Customer Name:		Gallien-Krueger		Current Rev #:	A1	New ECO Rev #:	A2		
Model:		Backline 250, 600, 115 Combo, and 210 Combo		Distribute To:		Page:	1	Of:	2
Assembly Description:				Originator:	Enrique Hernandez				
Assembly Numbers:		206-0181-A		Approved by:					
				Effective Date:	2/15/2005				
Effective				Document Update		Date	Initials		
<input checked="" type="checkbox"/>	All in Process	<input checked="" type="checkbox"/>	Next Buy	<input type="checkbox"/>	Artwork				
<input type="checkbox"/>	All in Service	<input checked="" type="checkbox"/>	Next Production Run	<input type="checkbox"/>	Assembly Dwg.				
<input checked="" type="checkbox"/>	All in Stock	<input type="checkbox"/>		<input type="checkbox"/>	Board Artwork				
Beginning Serial Number:				<input checked="" type="checkbox"/>	BOM		Noli		
Reason For Change				<input type="checkbox"/>	Control Form				
Pre-Amp revoiced to sound more like the 400RB-IV.				<input checked="" type="checkbox"/>	Costing		TC

TITLE: BACKLINE 115 PREAMP  
REV: A2  
DRAWING NO: 406-0181-A  
PART NO: 206-0181-A  
COMPANY: GALLIEN-KRUEGER  
FILENAME: 6181A.SCH

Customer Name:		Gallien-Krueger		Current Rev #:		A3		New ECO Rev #:		A4	
Model:		Backline 250

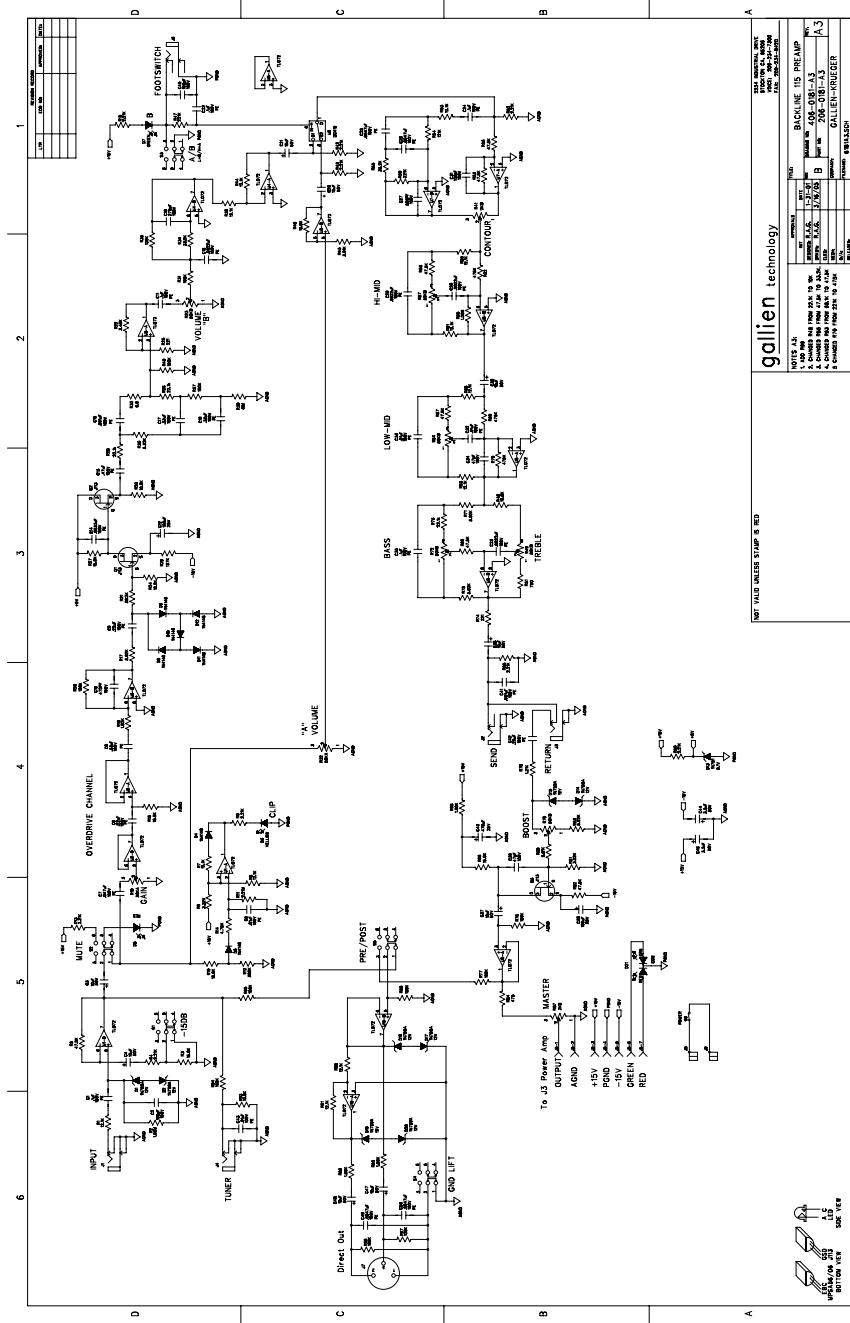
<input checked="" type="checkbox"/>	Incoming Q.C.				
				<input type="checkbox"/>	Planning				
				<input checked="" type="checkbox"/>	Production Eng.				
				<input checked="" type="checkbox"/>	Purchasing				
				<input type="checkbox"/>	Q.A.				
				<input type="checkbox"/>	Receiving				
				<input type="checkbox"/>	Service				
				<input type="checkbox"/>	Test				
				<input type="checkbox"/>	Vendor				
				<input type="checkbox"/>					
				<input type="checkbox"/>					
<input type="checkbox"/>	Continued on ECO Supplement Page			<input checked="" type="checkbox"/>	Drawing(s) attached				
Part Number	Description	Parts Added		Parts Deleted					
		Qty	Ref. Designator	Qty	Ref. Designator				
060-5622-0	1/8W, 5.62K			1	R48				
060-5622-0	1/8W, 5.62K			1	R51

1. Changed resistor R48 from 5.62K to 22K.  
2. Changed resistor R51 from 5.62K to 20K.  
3. Changed resistor R52 from 47.5K to 68K.  
4. Changed resistor R53 from 47.5K to 68K.  
5. Changed resistor R54 from 47.5K to 22K.  
6. Changed resistor R55 from 47.5K to 22K.

TITLE: BACKLINE 115 PREAMP  
DRAWING NO: 406-0181-A4  
PART NO: 206-0181-A4  
COMPANY: GALLIEN-KRUEGER  
RELEASED: 2/2/03  
FILENAME: 6181A4.SCH

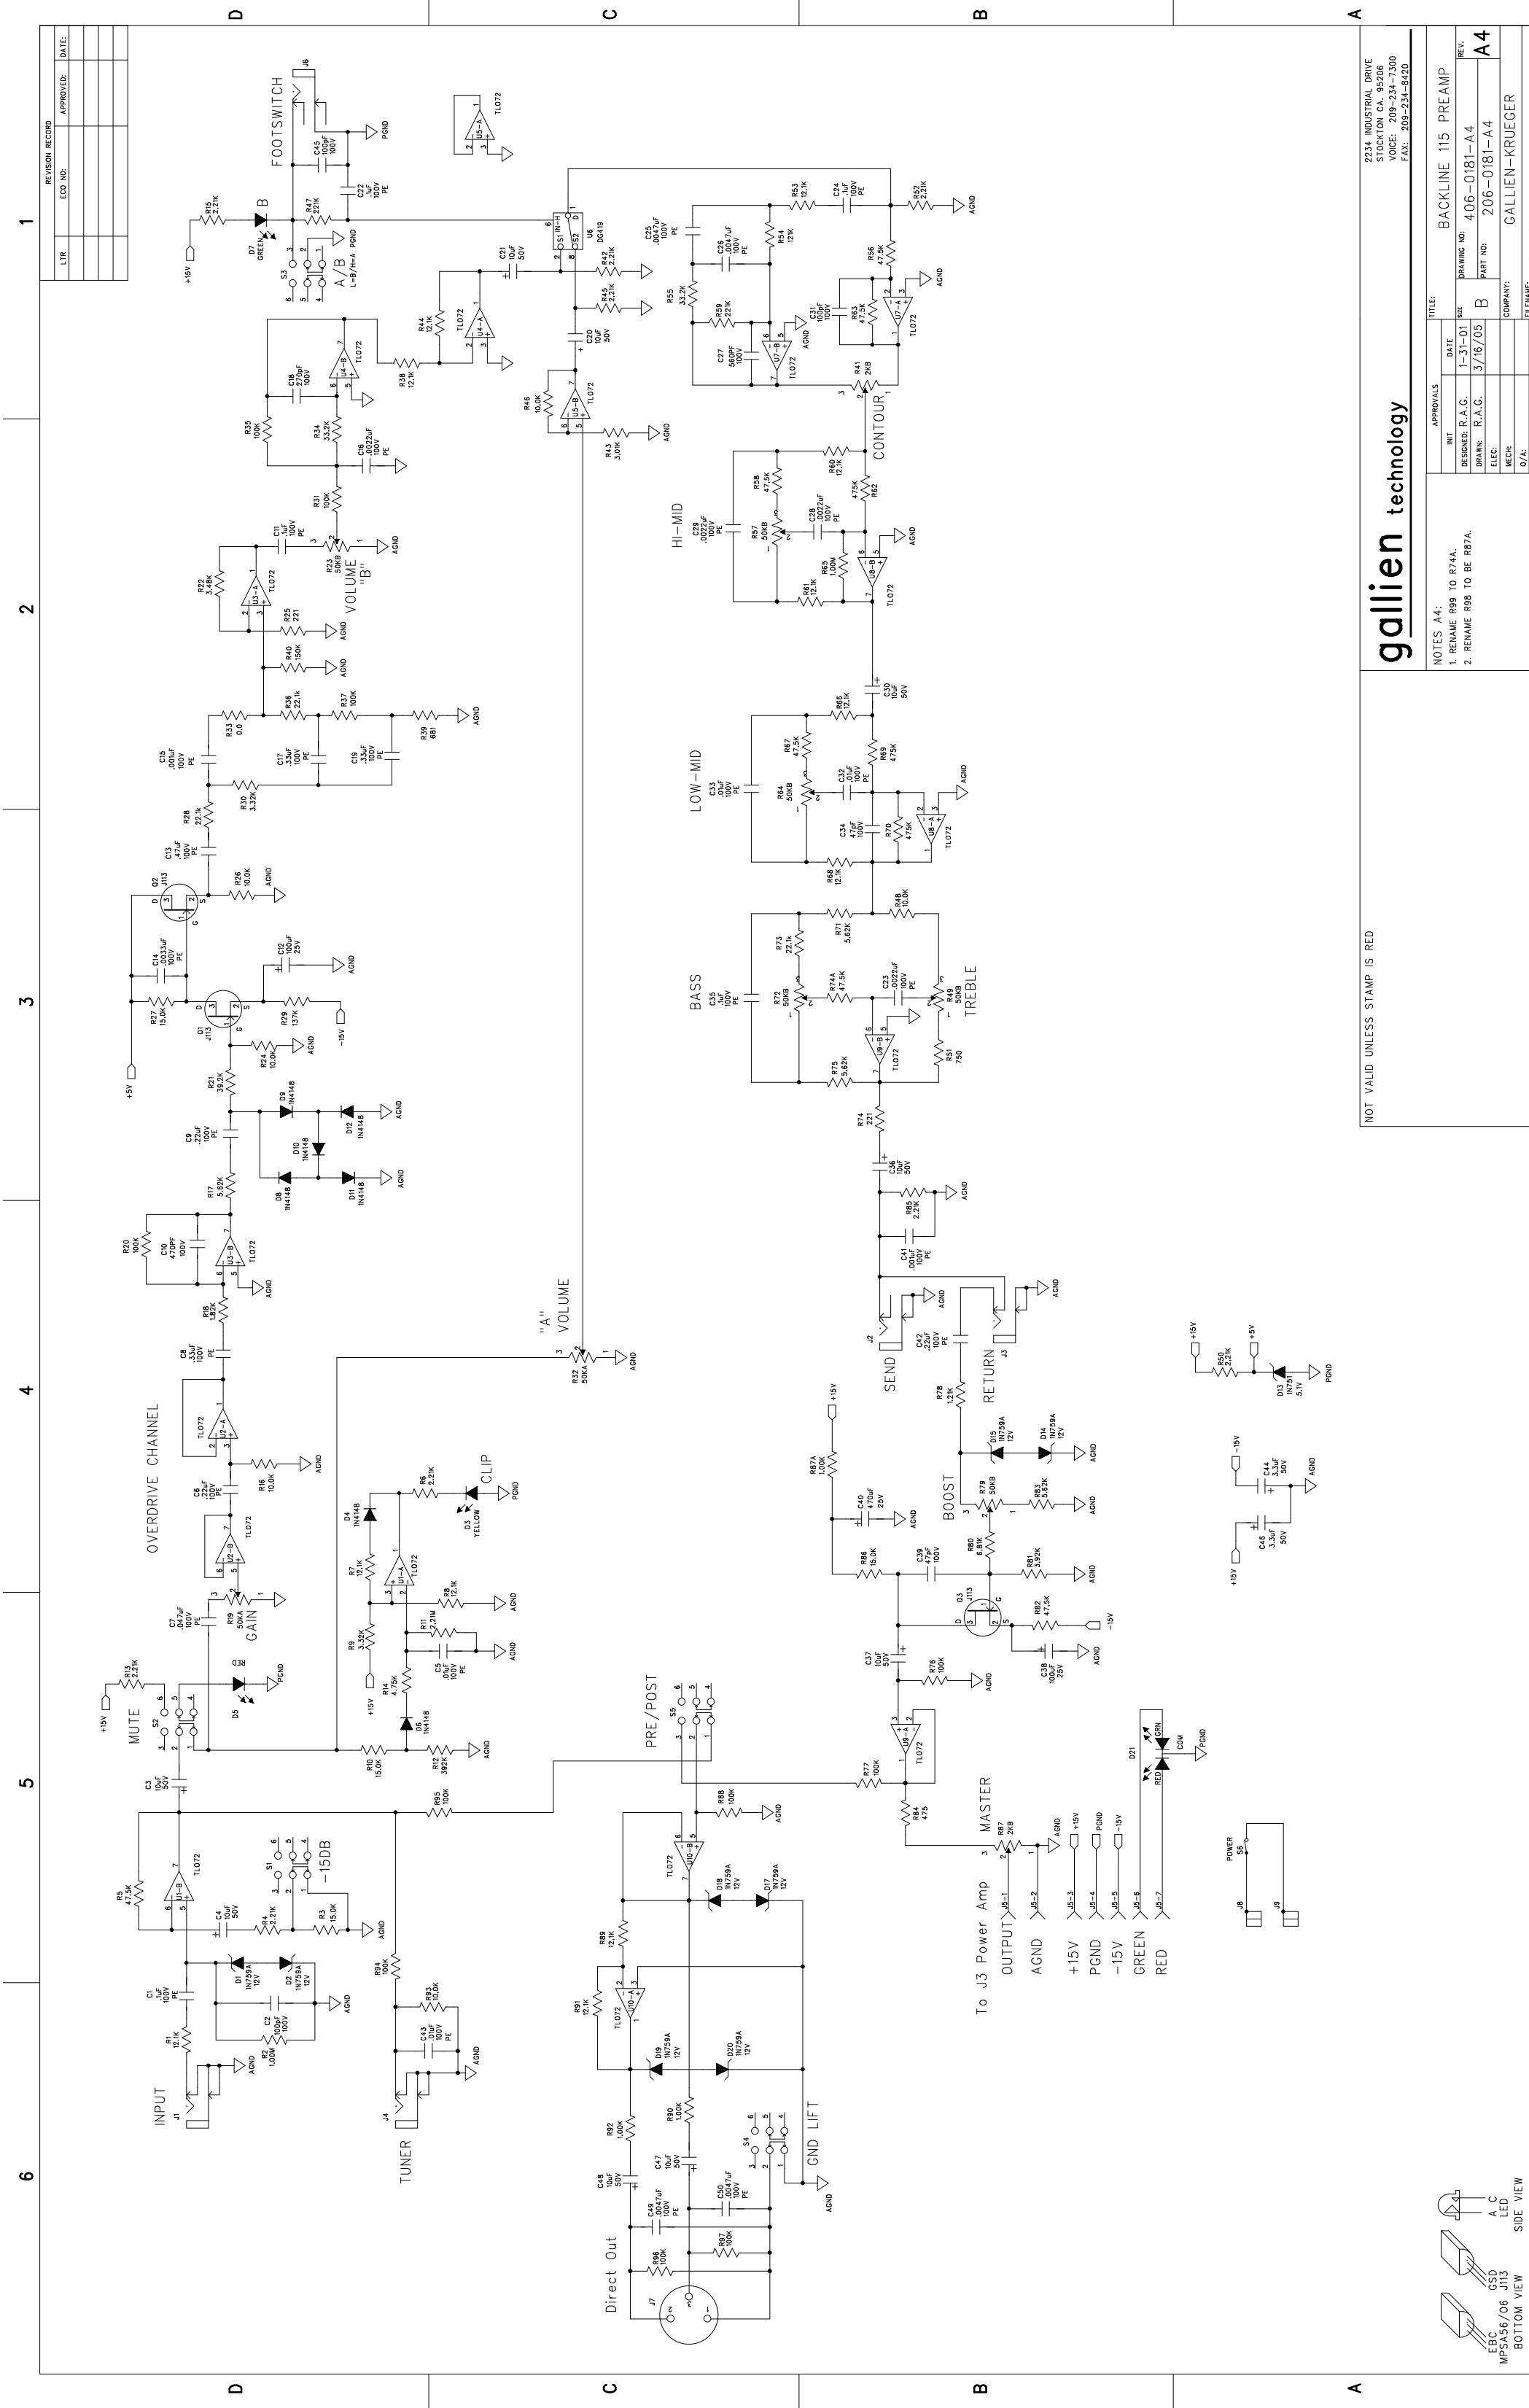
<input type="checkbox"/>	Fab Drawing						
				<input type="checkbox"/>	Inspection Proc.						
				<input checked="" type="checkbox"/>	Part Master File						Noli
				<input checked="" type="checkbox"/>	Schematic						RAG
				<input type="checkbox"/>	Service Manual						
				<input type="checkbox"/>	Test Procedure						
				<input type="checkbox"/>							
				<input type="checkbox"/>							
				Other Affected Assemblies							
				209-0180-A, 303-0180-A,							
				303-1180-A, 303-2180-A							
<input type="checkbox"/>	Continued on ECO Supplement Page										
Description Of Change				Distribution				Date		Initials	
Update BOM.				<input type="checkbox"/>	Accounting						
				<input type="checkbox"/>	Assembly						
Update Part Master File.				<input type="checkbox"/>	Customer						
				<input checked="" type="checkbox"/>	Engineering						
Updated Artwork 145-0181-A4.				<input checked="" type="checkbox"/>	Incoming Q.C.

<input type="checkbox"/>	Planning						
Resistor R98 changed to R87A, and resistor R99 changed to R74A.				<input checked="" type="checkbox"/>	Production Eng.						
				<input checked="" type="checkbox"/>	Purchasing						
				<input type="checkbox"/>	Q.A.						
				<input type="checkbox"/>	Receiving						
				<input type="checkbox"/>	Service						
				<input type="checkbox"/>	Test						
				<input type="checkbox"/>	Vendor						
				<input type="checkbox"/>							
				<input type="checkbox"/>							
				<input checked="" type="checkbox"/>	Drawing(s) attached						
Part Number		Description		Parts Added				Parts Deleted			
				Qty	Ref. Designator			Qty	Ref. Designator

NOTES: A4:  
1. RENAME R98 TO R74A.  
2. RENAME R98 TO BE R97A.

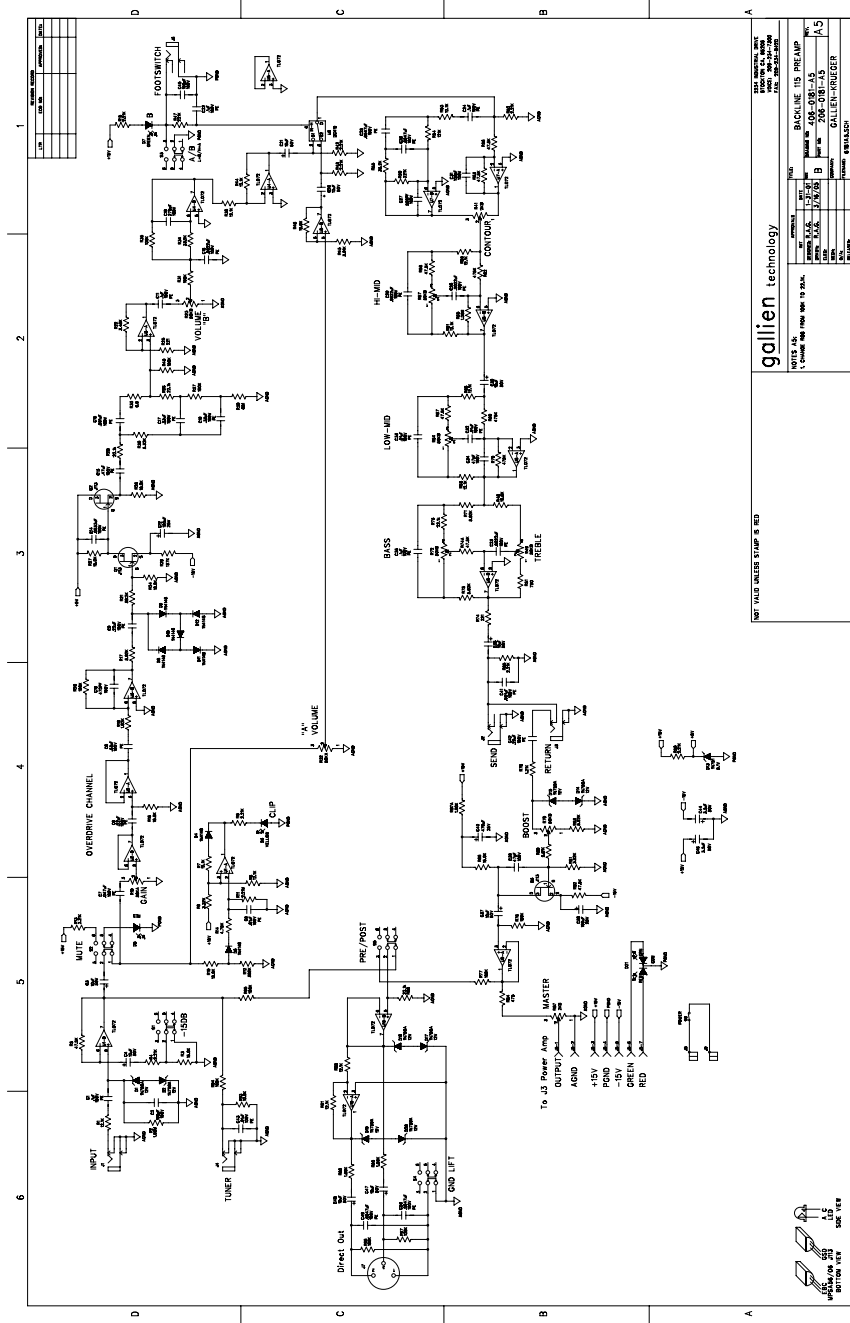
<input checked="" type="checkbox"/>	Production Eng.						
				<input type="checkbox"/>	Purchasing						
				<input type="checkbox"/>	Q.A.						
				<input type="checkbox"/>	Receiving						
				<input type="checkbox"/>	Service						
				<input type="checkbox"/>	Test						
				<input type="checkbox"/>	Vendor						
				<input type="checkbox"/>							
				<input type="checkbox"/>							
<input type="checkbox"/>	Continued on ECO Supplement Page			Drawing(s) attached							
Part Number	Description	Parts Added		Parts Deleted							
		Qty	Ref. Designator	Qty	Ref. Designator						
206-1001-A	1001 1/01B Rev			1	1001
